FSCF Changes into Final Design

Slides from Arup Final Design Kick-Off Meeting (11/7/17)

April 11, 2018

Underground Communications

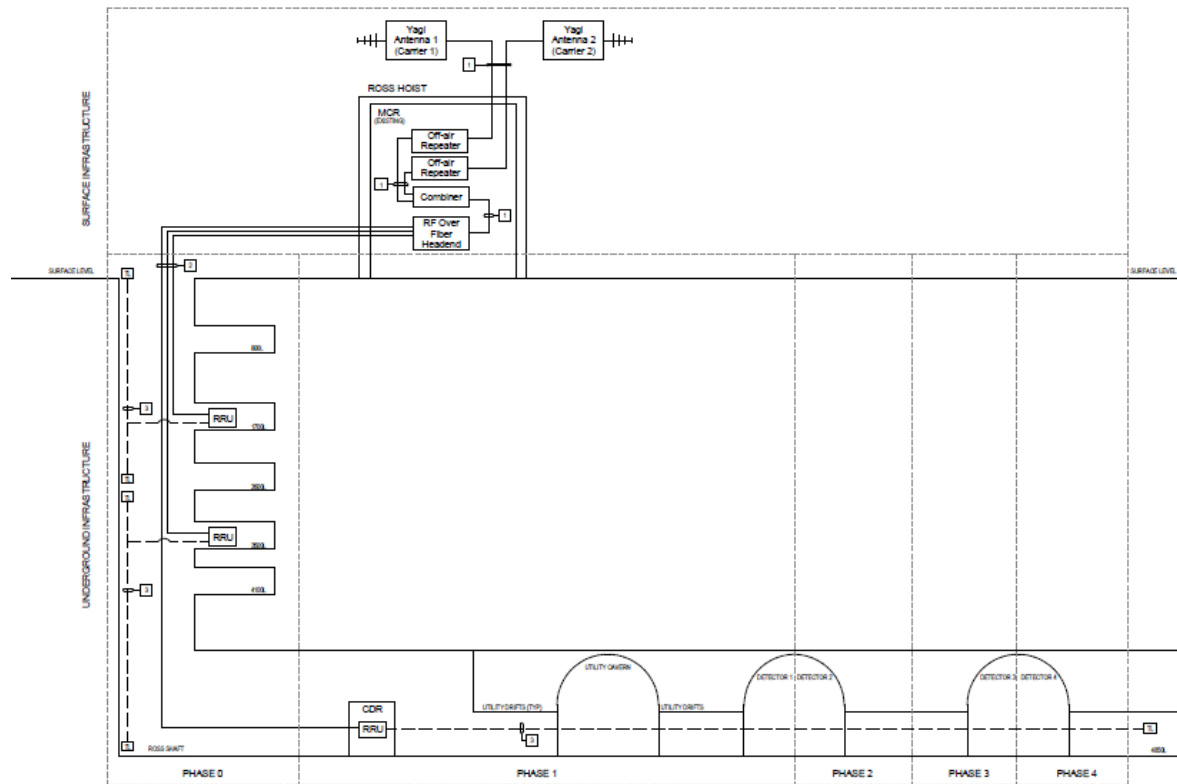
- Preliminary Design Scope for Leaky Feeder System – Scope Option
- Final Design Scope – To remain as a Scope Option

Surface Mechanical

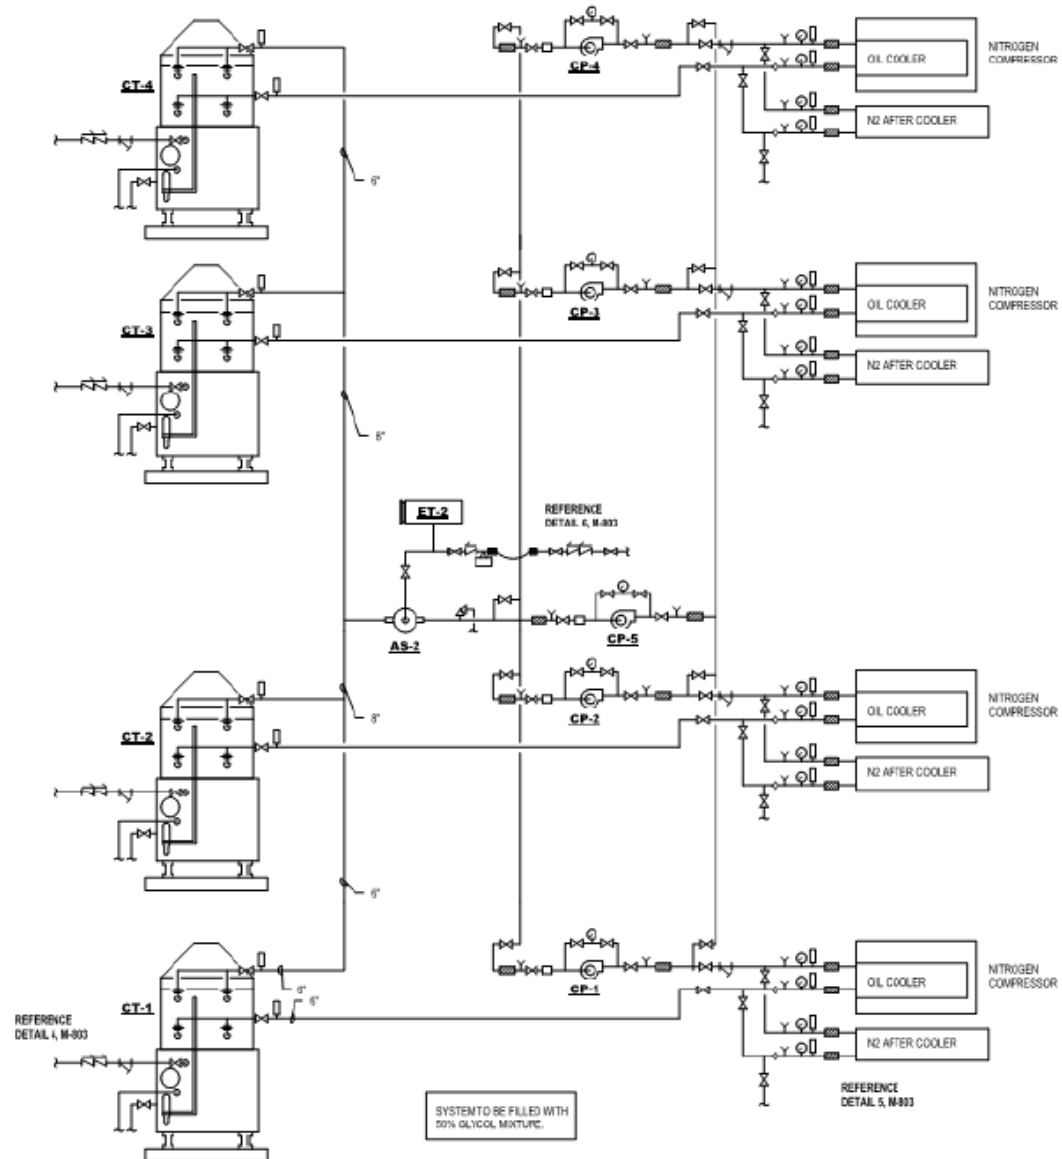
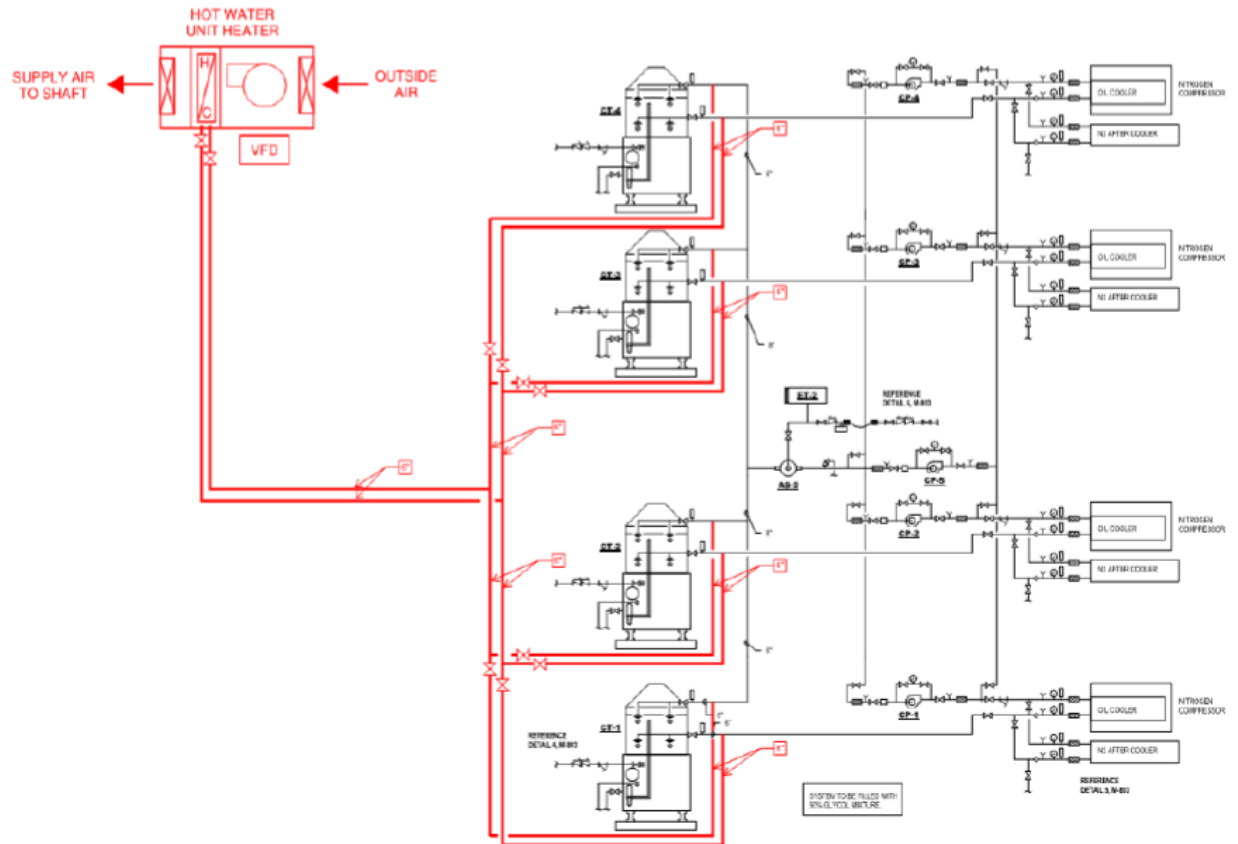
- Current Preliminary Design utilizes Cooling Towers for 100% Heat Rejection

- Incorporate the plan from the Advanced Preliminary Design task for utilization of waste heat from the Cryogen compressors to heat the Intake Air for the Ross Shaft
- Cooling Towers are to remain to provide cooling during warm periods where Shaft Intake air does not require heating

Surface Civil – Cryogen Building

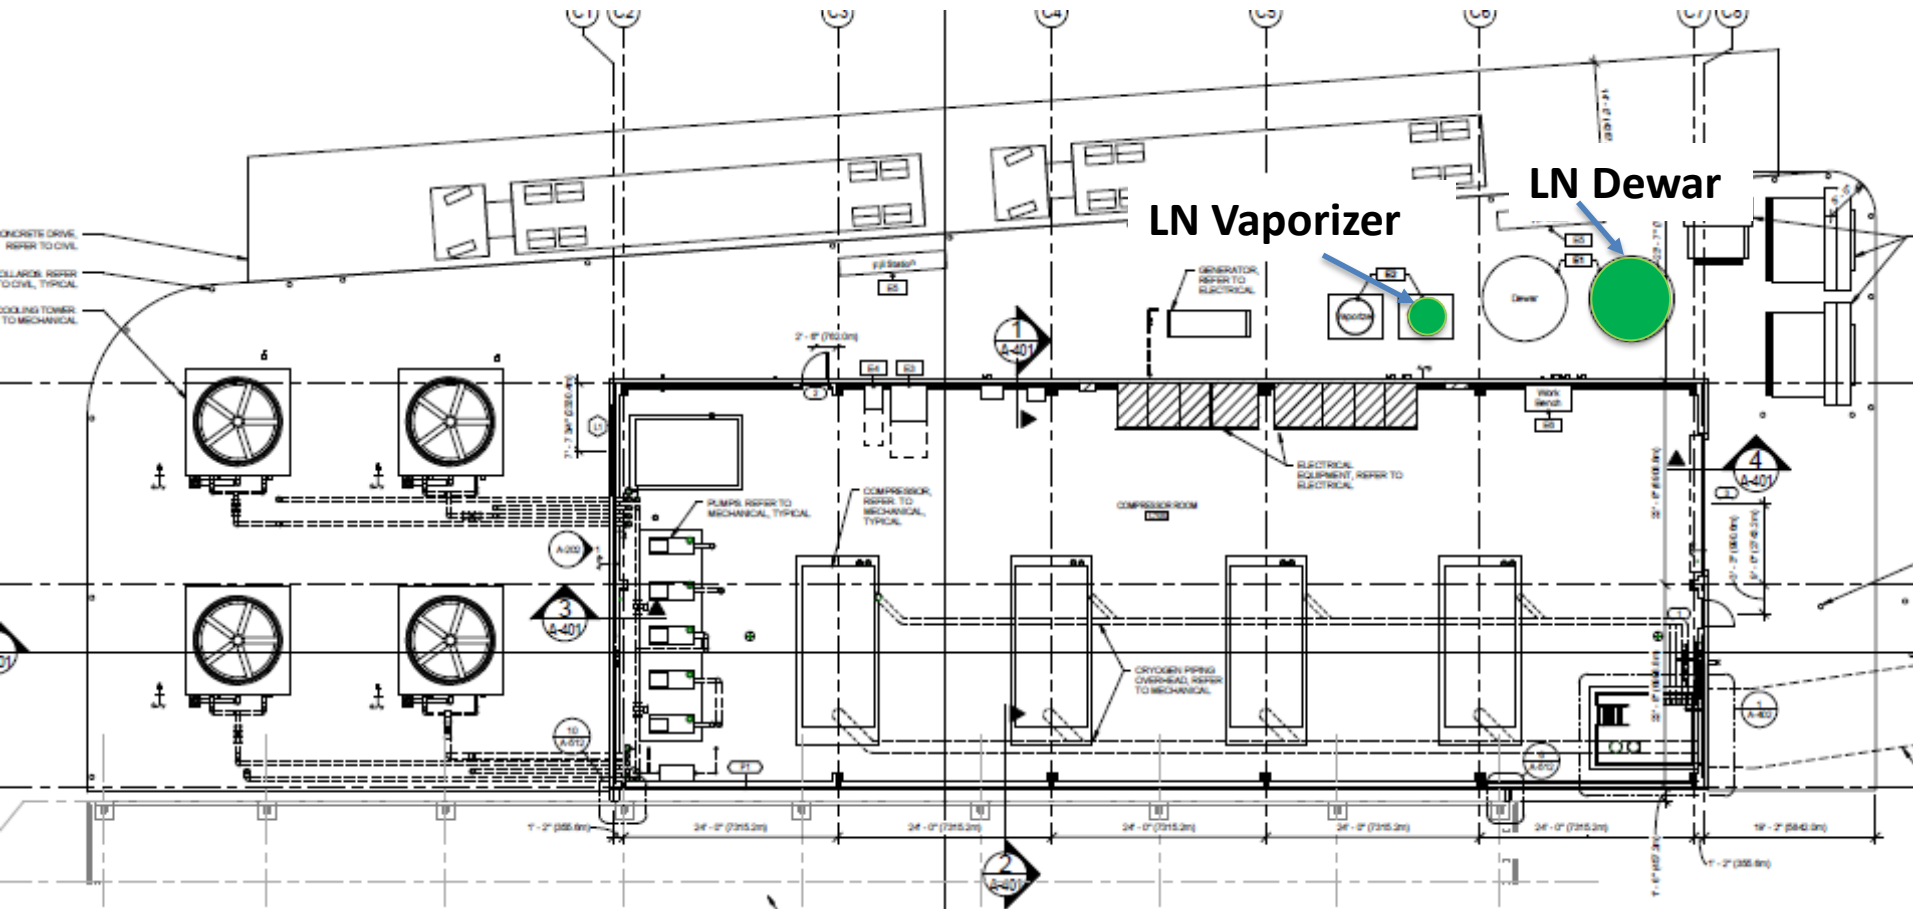
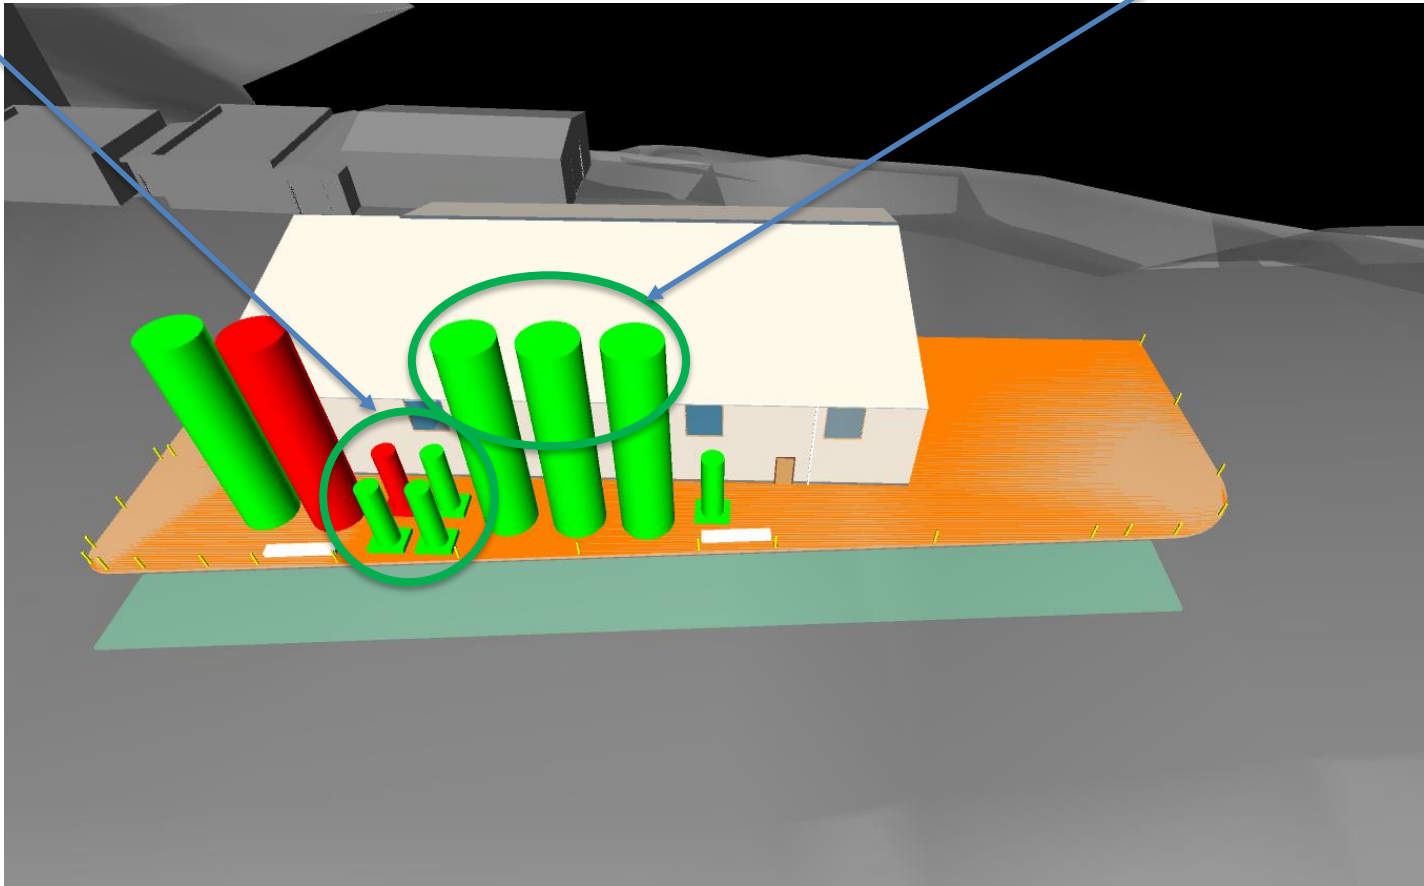
- Preliminary Design for the Cryogen Building considered only 1 Liquid Argon Storage Dewar and 1 Vaporizer

- Final Design for the Cryogen must incorporate an additional 3 Liquid Argon storage dewars into the design
- Also need 3 additional Liquid Argon Vaporizers

Underground Electrical - Detector Electronics

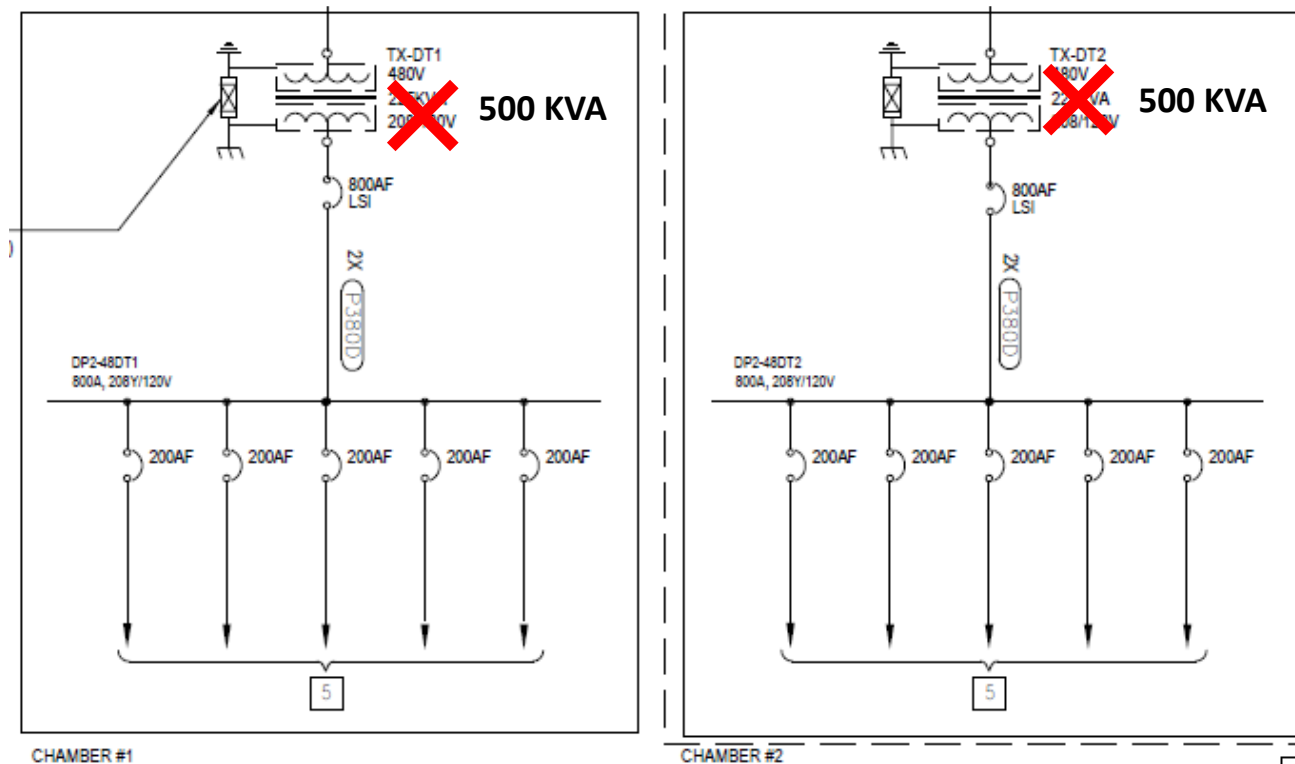
- Preliminary Design requirement for Detector Electronics – 225 KVA Transformers
- Final Design Change – 500 KVA Transformers

Underground Electrical

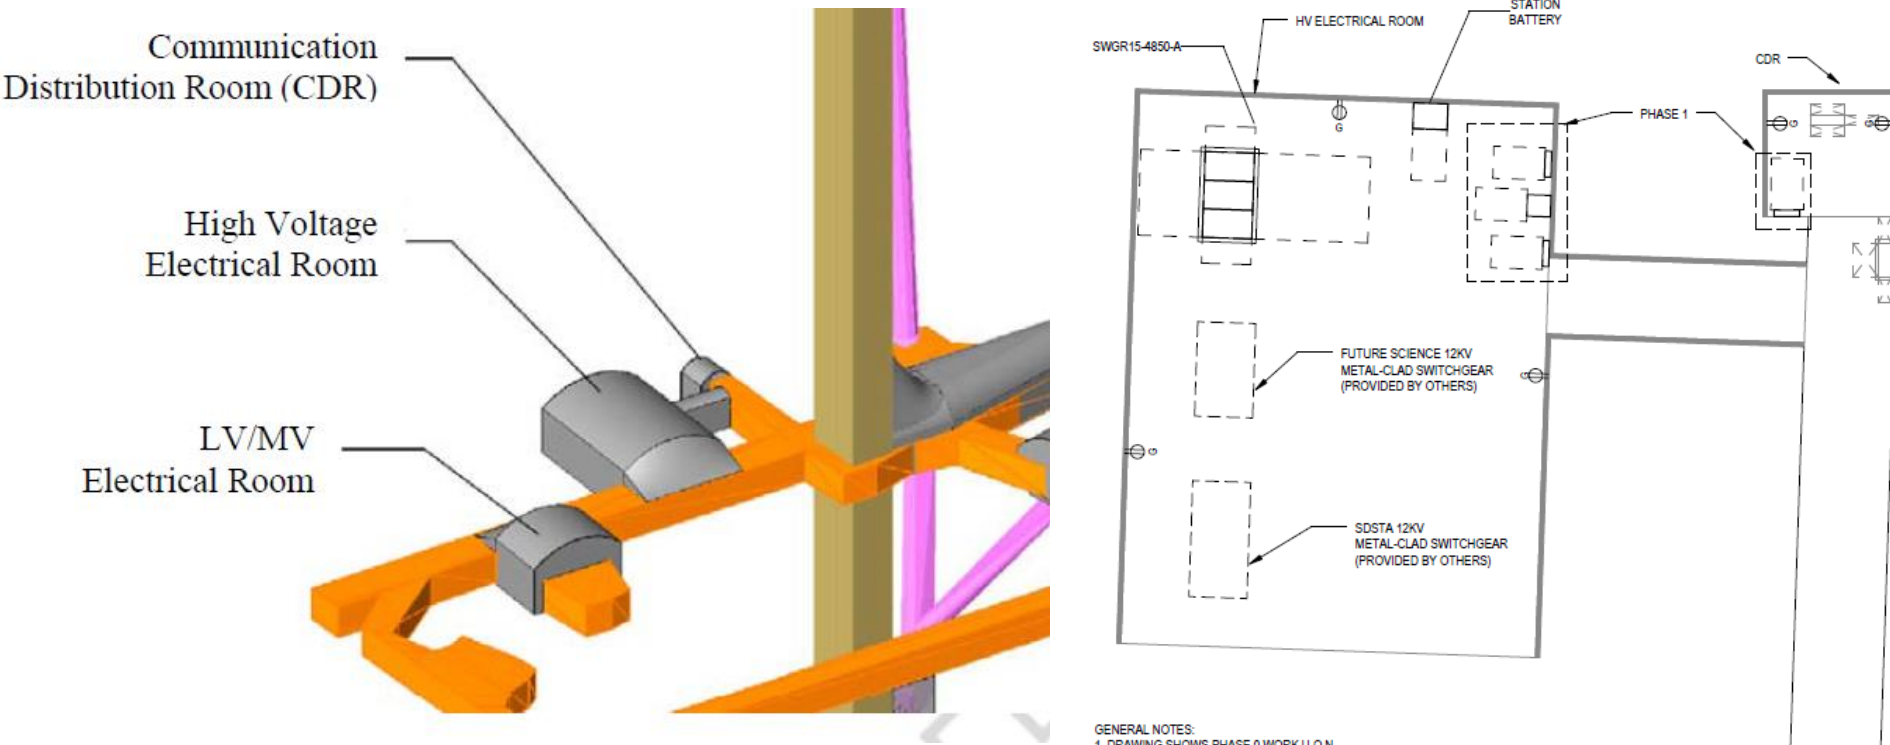
- Design for Underground Substation to be updated as per Advanced Preliminary Design Concept

Changes to EXC scope – Infrastructure – 4850L Ross Shaft Brow & Access Drift Design

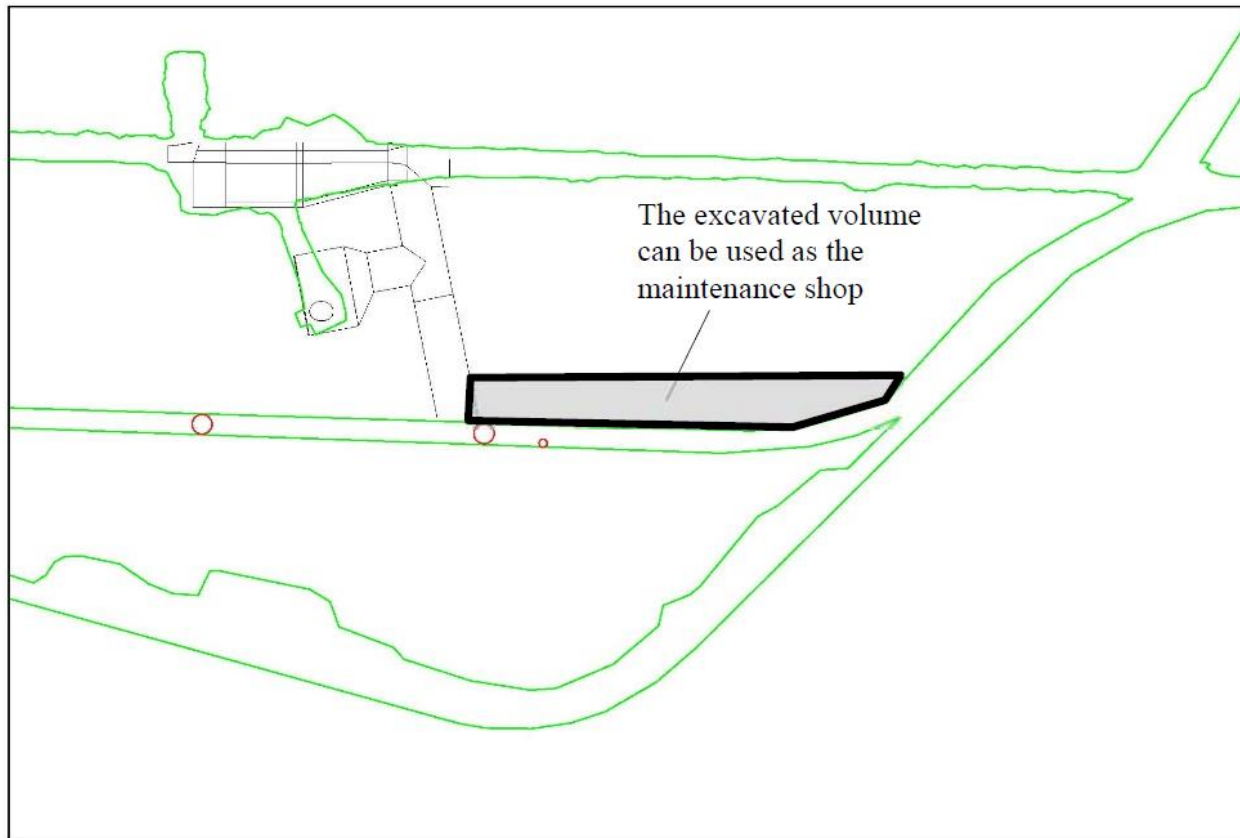
- The Final EXC Design shall include the findings of the Underground Electrical Substation Relocation Feasibility Study/Conceptual Design.
- Will also provide space for equipment maintenance initially

Underground Architectural/Electrical/Mechanical

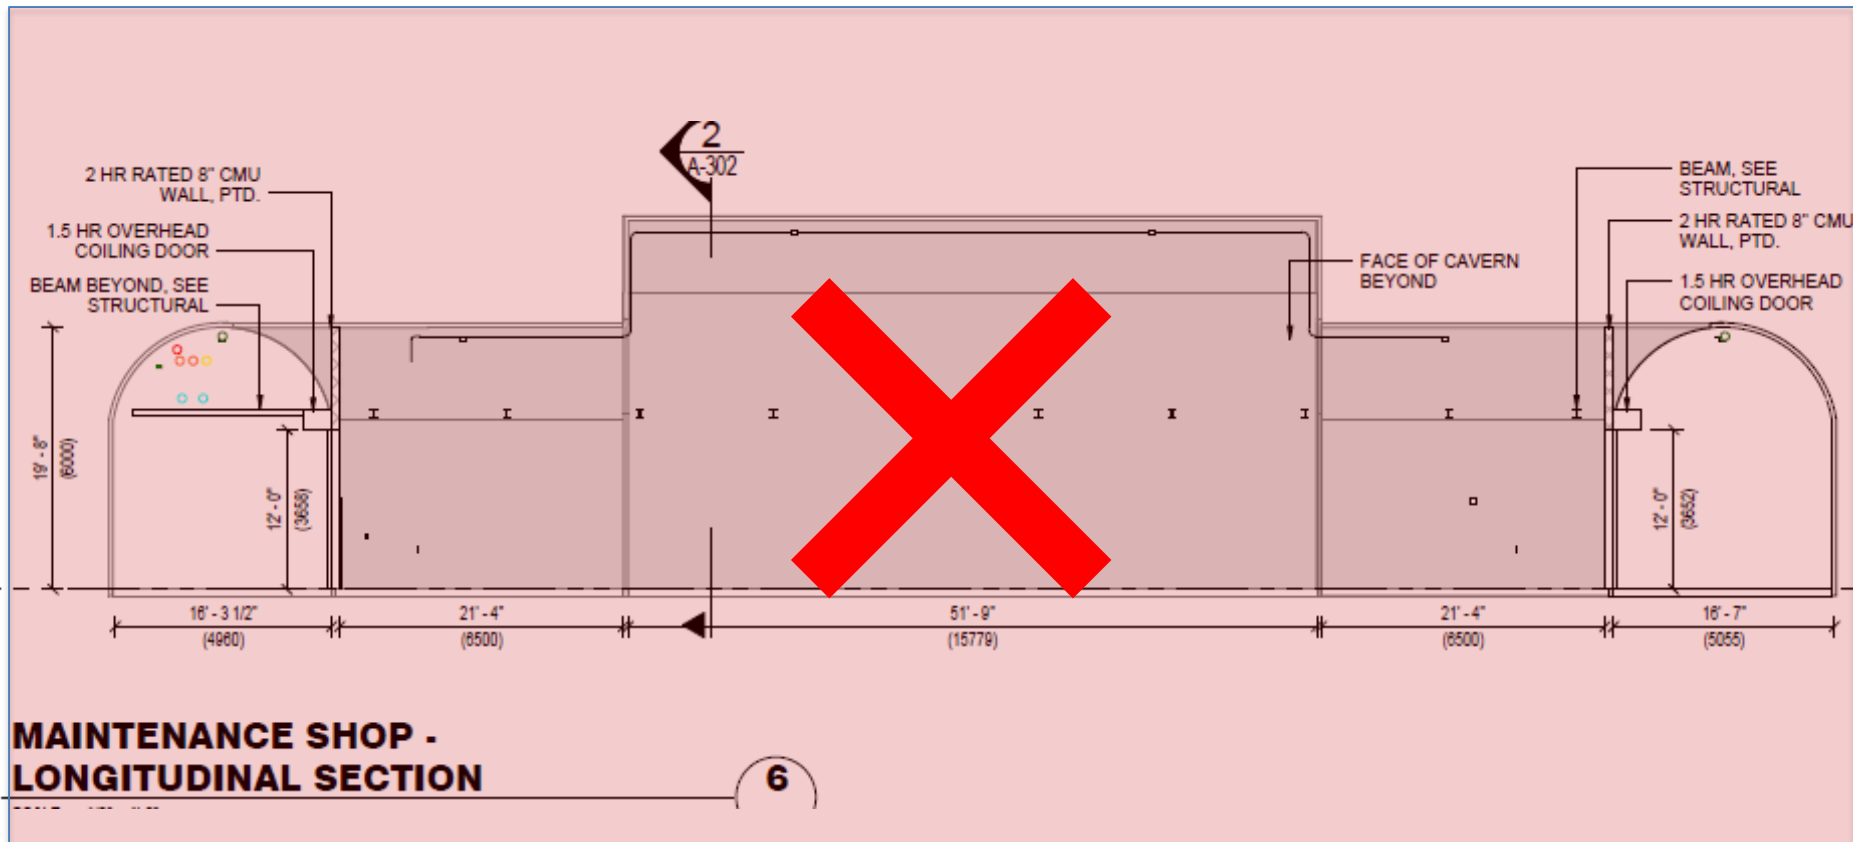
- Separate Maintenance Shop no longer required.
